CLAREMONT BUSINESS PARK 2 FIL. NO. 1 - LOT 3

EL PASO COUNTY, STATE OF COLORADO GRADING & EROSION CONTROL PLAN

EPC STORMWATER REVIEW COMMENTS ARE SHOWN IN ORANGE BOXES WITH BLACK TEXT

GRADING & EROSION CONTROL PLAN
CLAREMONT BUSINESS PARK 2 FIL. NO. 1 - LOT 3
JOB NO. 44-037
DATE PREPARED: FEBRUARY 15, 2021
DATE REVISED:

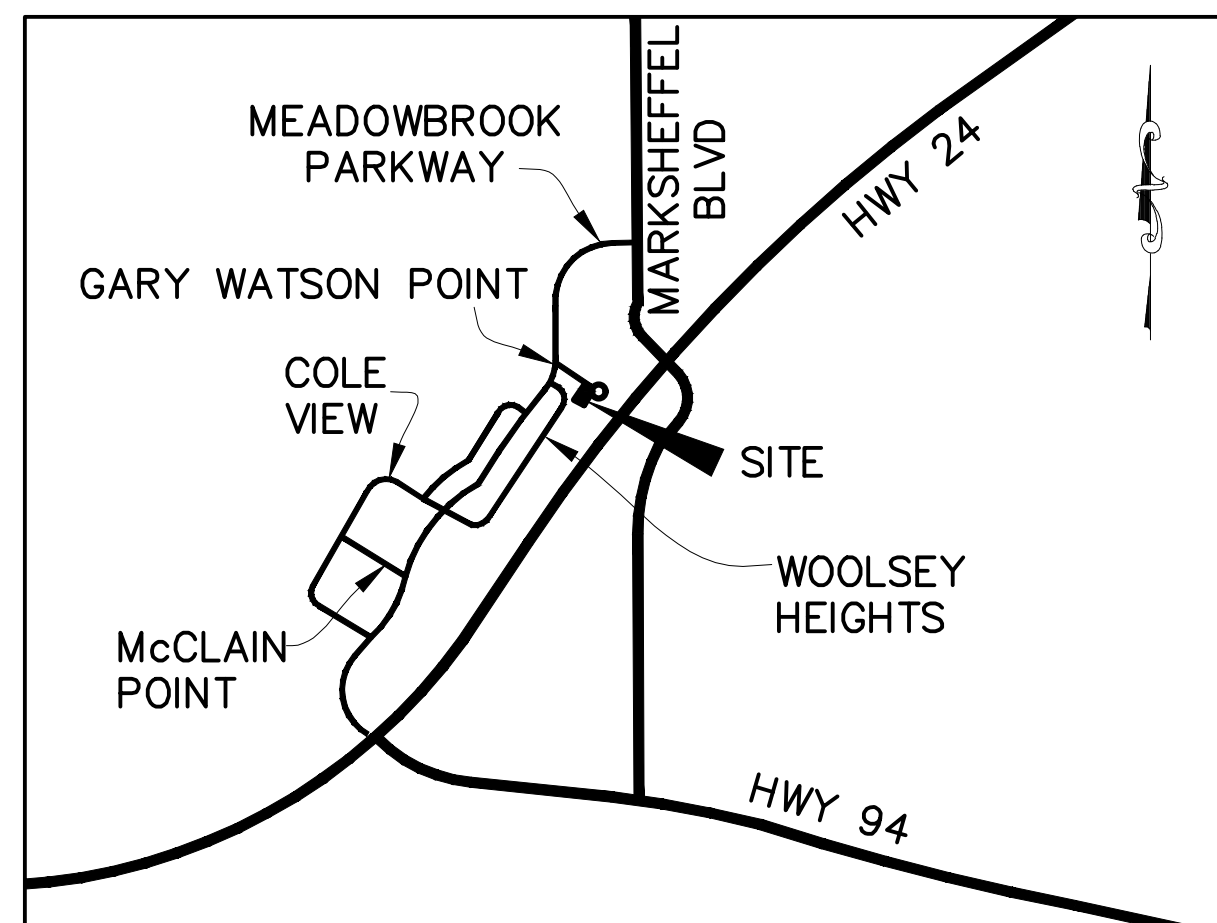
Update PCD File No. to PPR2111.

show areas of temporary and permanent seeding. add symbol to legend

Add a note about existing vegetation and percent cover (prior to early grading).

Add a note stating no asphalt/concrete batch plants are associated with this project.

Add a note stating there are no springs, streams, or wetlands at the Site.

No temporary seeding is anticipated for this project. As to not overly encumber the plans, please see the landscaping plans landscaping and seeding information for this project

GRADING & EROSION CONTROL PLAN
CLAREMONT BUSINESS PARK 2 FIL. NO. 1 - LOT 3
JOB NO. 44-037
DATE PREPARED: FEBRUARY 15, 2021
DATE REVISED:

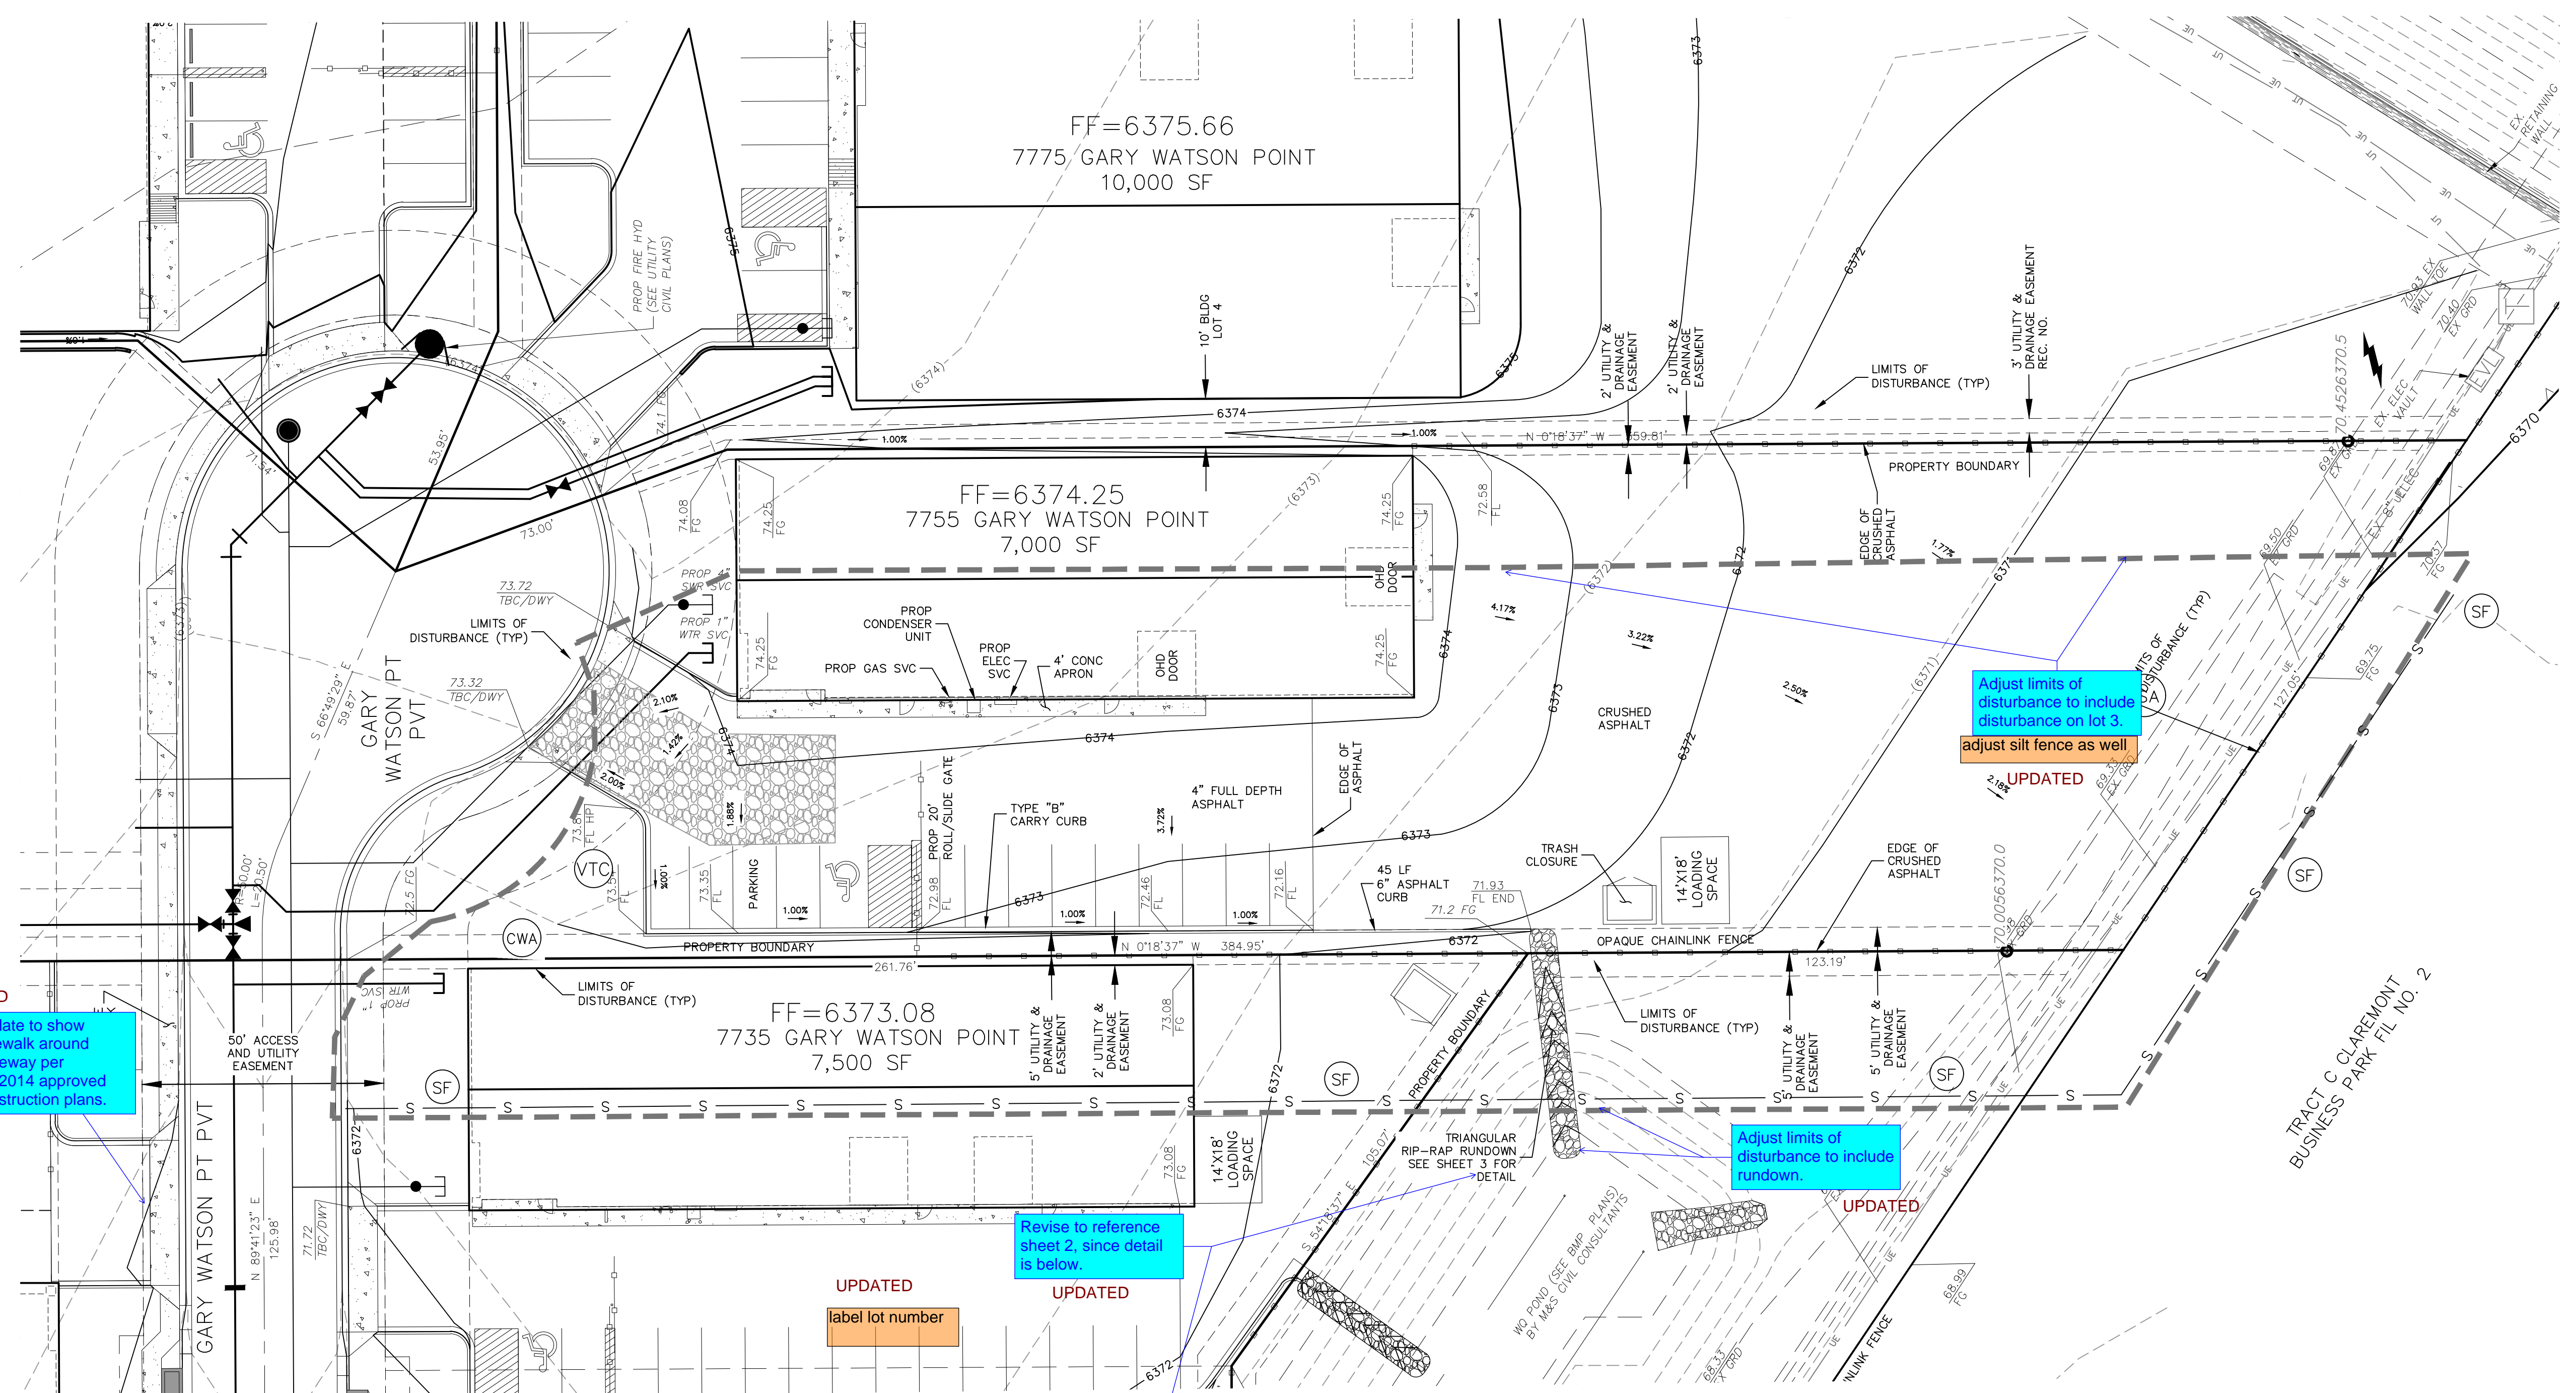
UPDATED
Label all proposed temporary construction control measures by phase of implementation (initial, interim, final)

UPDATED
Update to show sidewalk around driveway per SF-2014 approved construction plans.

If "limits of disturbance" and "construction boundary" are the same, change to "construction boundary/limits of disturbance" or otherwise show as separate line types for each on the legend and figure.

show areas of cut/fill

Provide riprap gradation table and note that CDOT Section 506 Requirements apply
